**Town of Kittery  
Planning Board Meeting  
April 11, 2019**

**ITEM 3 - Wilson Road – Minor Subdivision Sketch Plan Review**

Action: Accept or deny application; Approve or deny sketch plan. Owner Kerry A. Major and applicant Paul Hollis request consideration of a minor subdivision to construct a duplex on a 6.38-acre parcel located on Wilson Road, (Tax Map 54 Lot 20) in the Residential-Rural (R-RL) and Shoreland Overlay (OZ-SL-250') Zones.

**SITE PLAN**

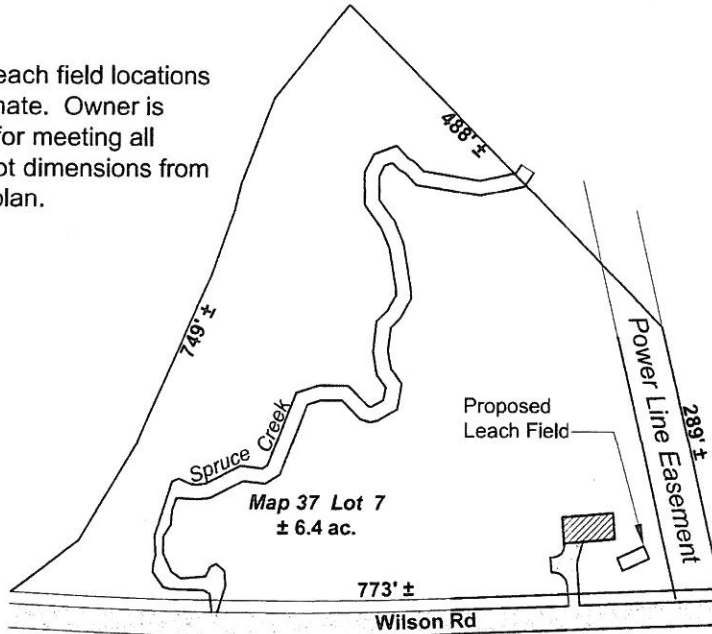
6. Utilities / Available Community Facilities. Information has been provided for the proposed subsurface wastewater disposal system. The test pit (TP#3) location is shown on the plan in the area of the proposed duplex.
